APPENDIX G

Stormwater Management Report - Aura Precinct 15

Prepared for Stockland Development
Pty Ltd

16 March 2022

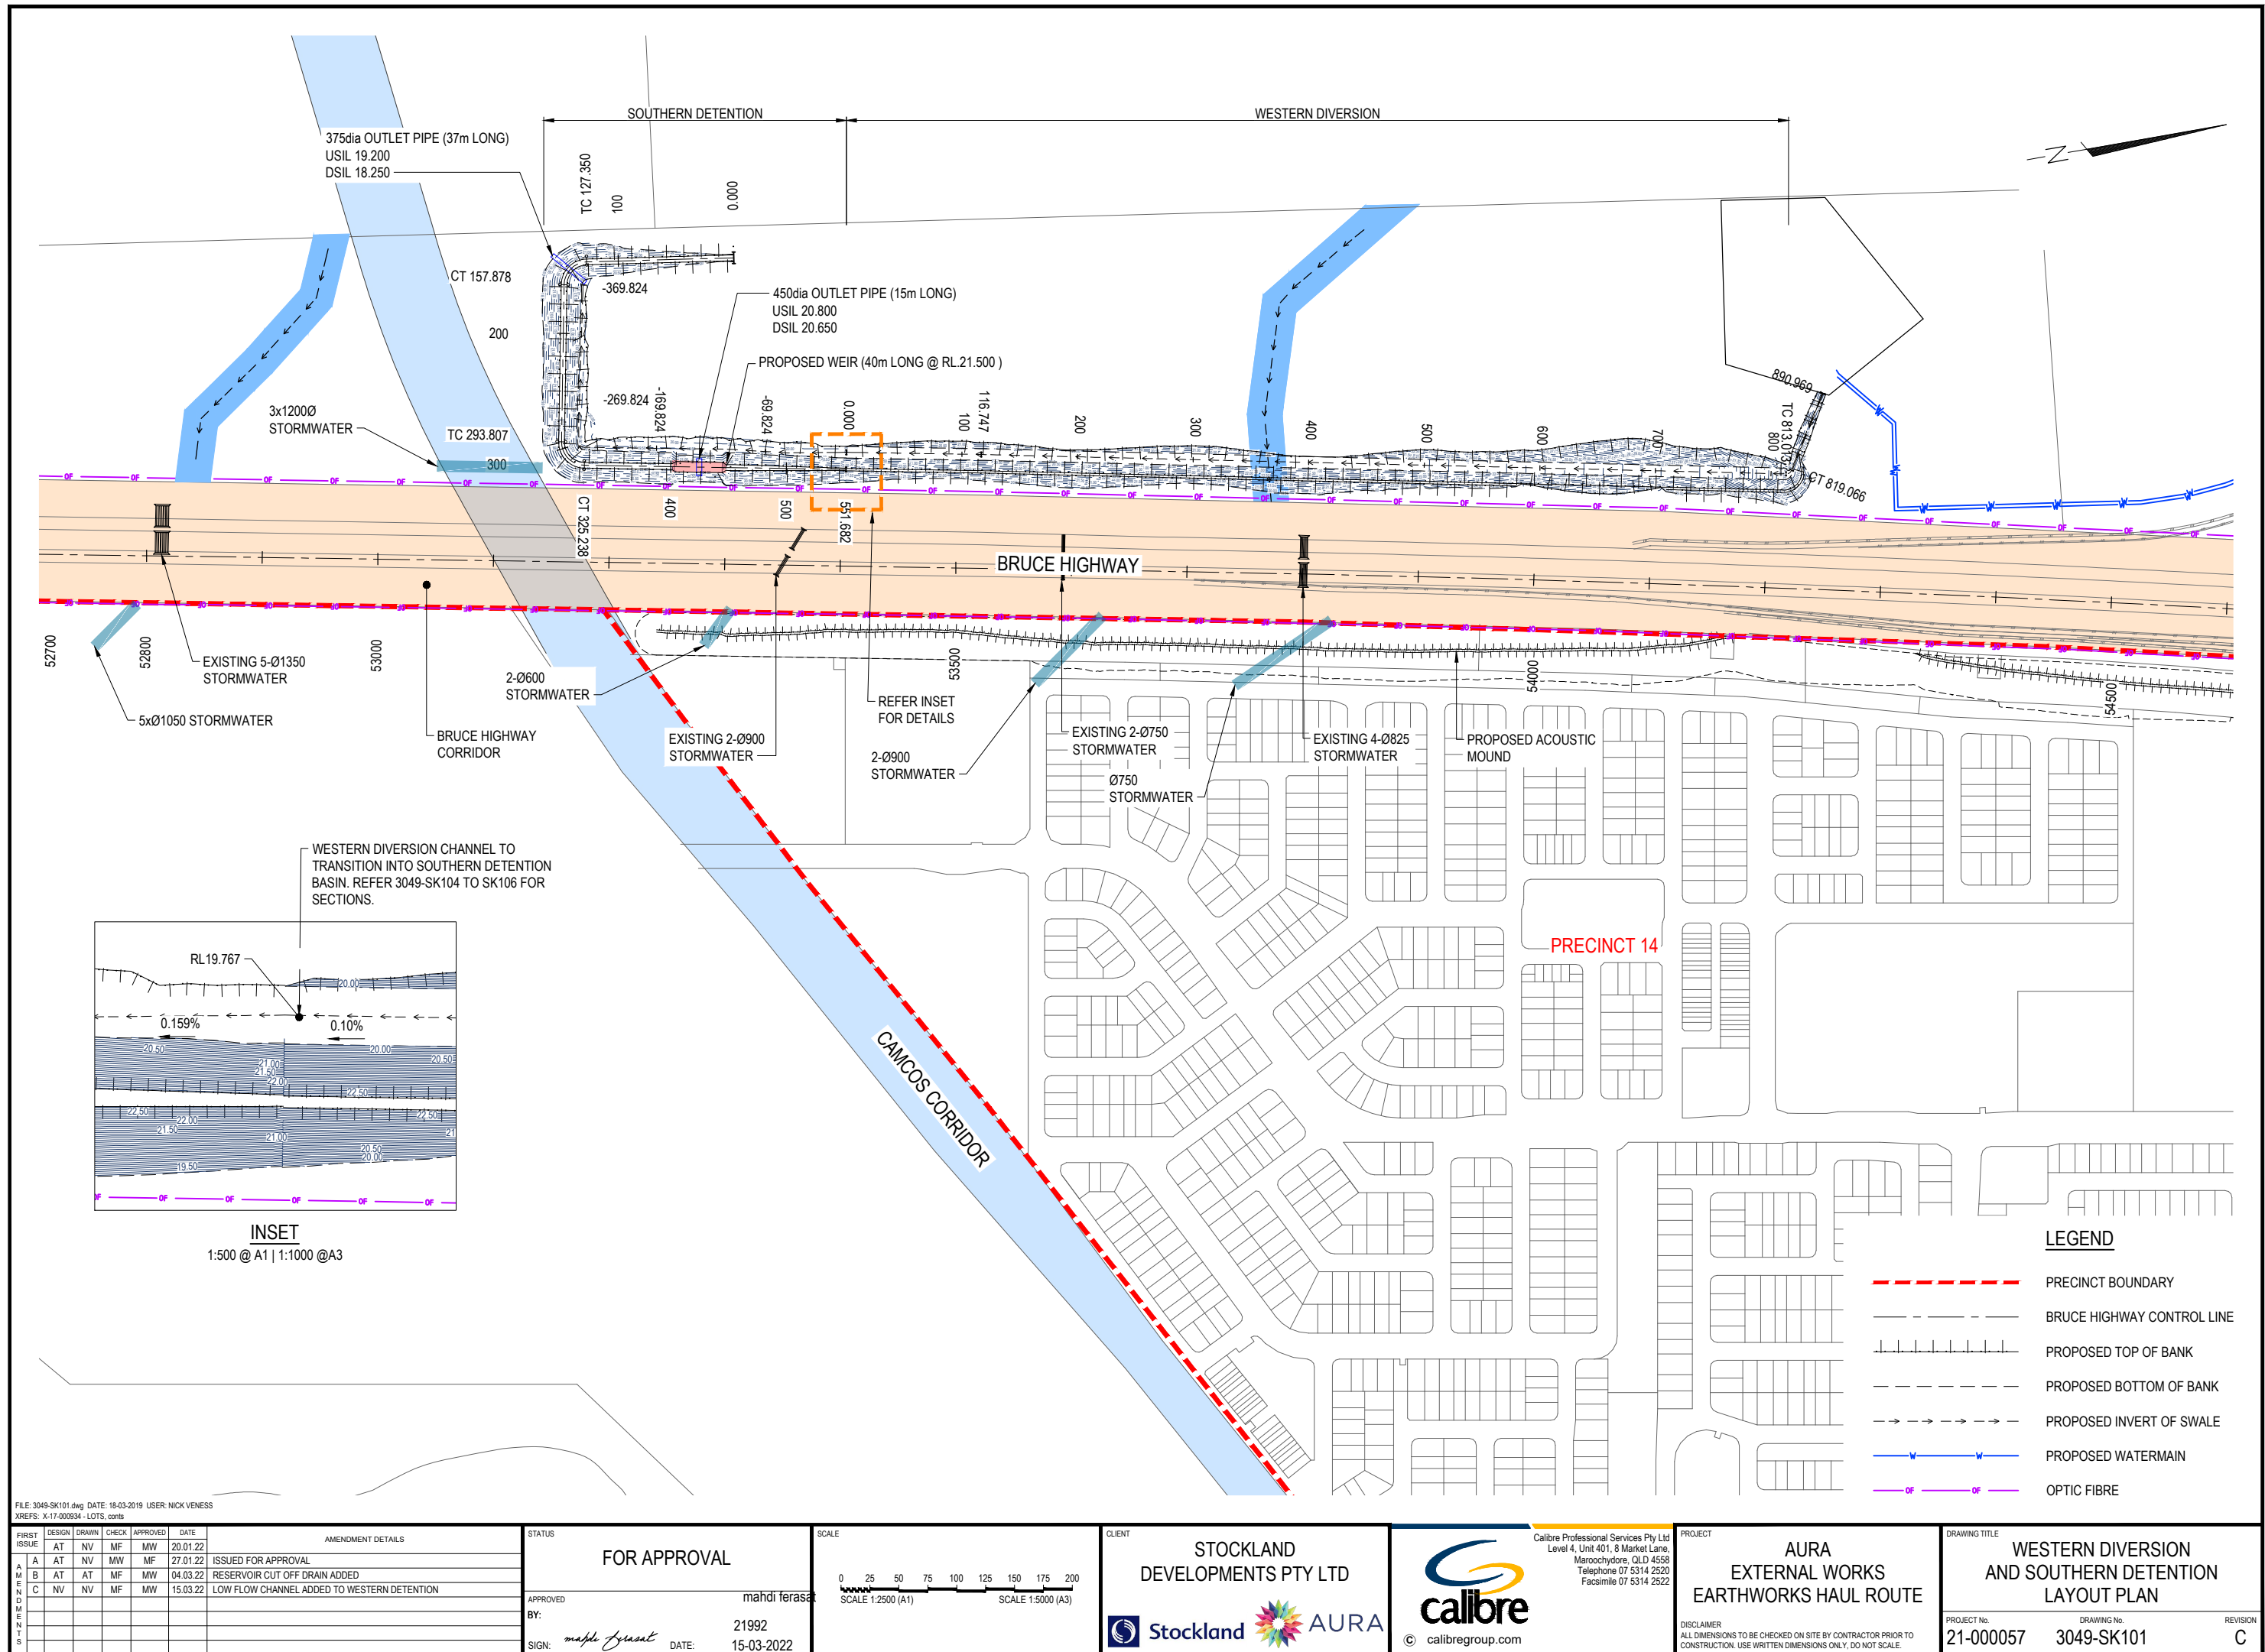
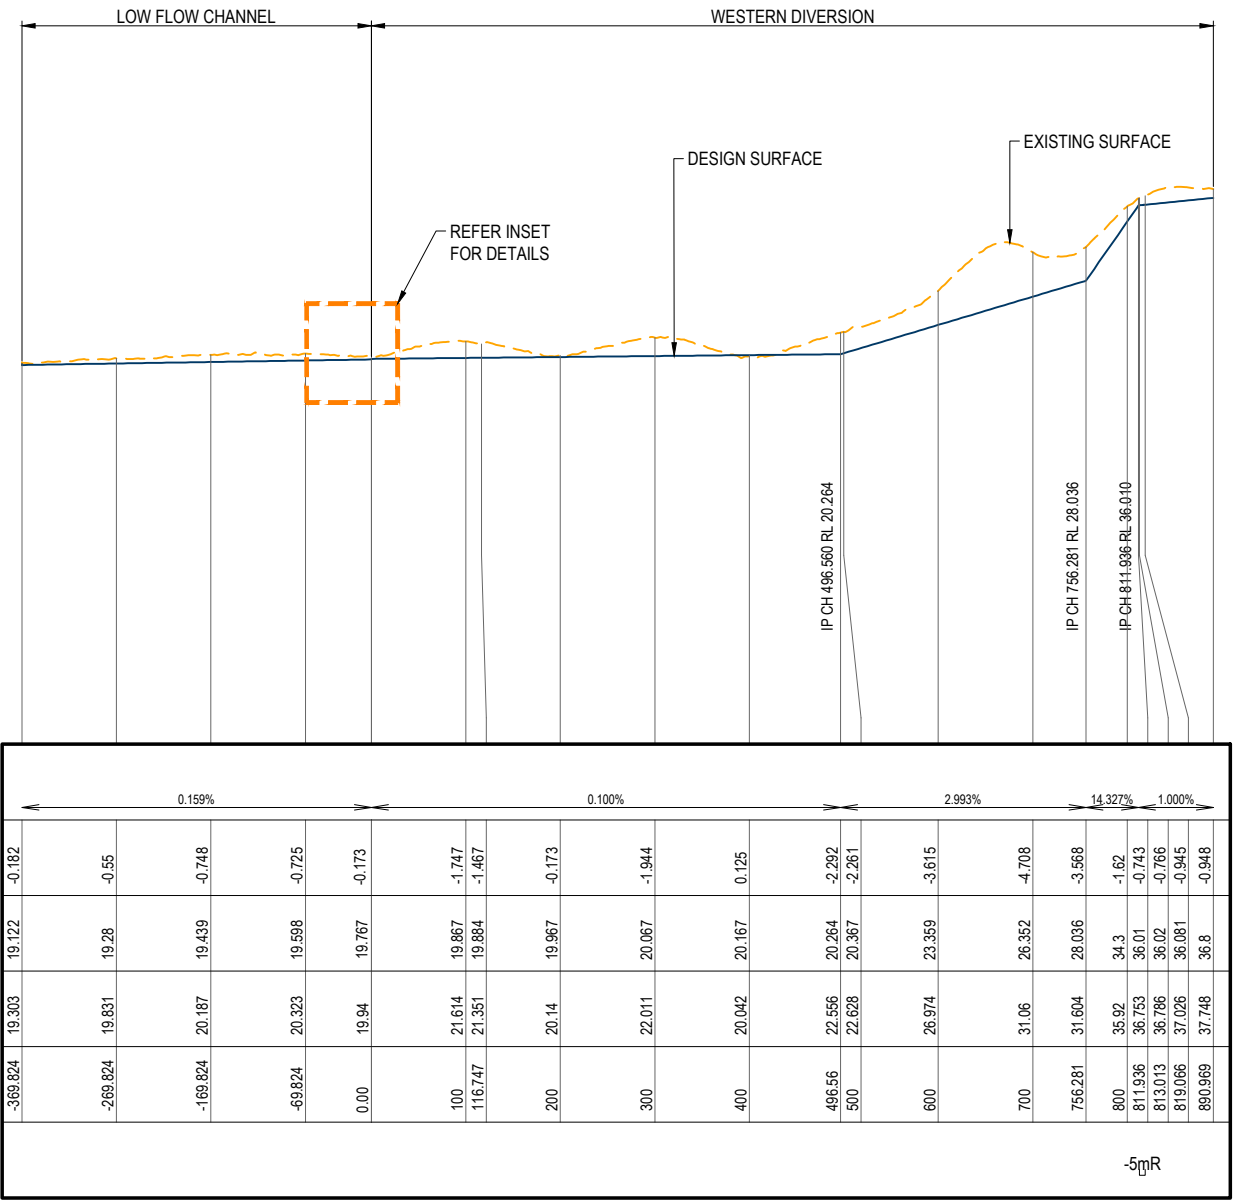
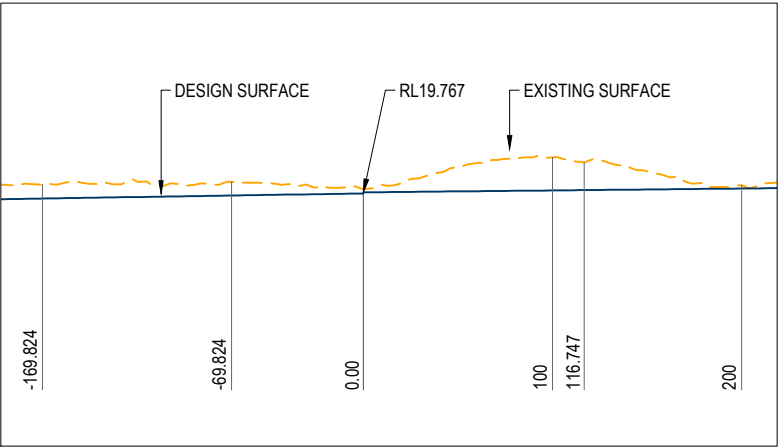
3. *The External Works plans prepared by Calibre, Drawings 3049-SK100 to 3049-SK109 do not clearly demonstrate that the proposed channel and detention basin works don't encroach into the Bruce Highway road corridor. RPEQ certified detailed design drawings must be provided that clearly detail the road corridor and future rail corridor, location of the channel and detention basin works and the proposed setbacks.*

Calibre's response 3: Calibre Drawings 3049-SK100 to 3049-SK109 provided as **Attachment 4** have been updated accordingly. The Bruce highway and CAMCOS corridors are demonstrated in the drawings (3049-SK 100 & 101). The channel and bund locations and their setbacks and distances from the abovementioned corridors are included in cross sections 3049-SK104 to SK-107 Furthermore, the modelling described in the Technical Memorandum has been revised (Revision C in Attachment 1) to include a 3x1200 RCP culvert crossing of the future CAMCOS rail embankment that adequately conveys runoff from a 1% AEP plus 2100-yr climate change event. These works are by others. Interim works will be an overland flow path.
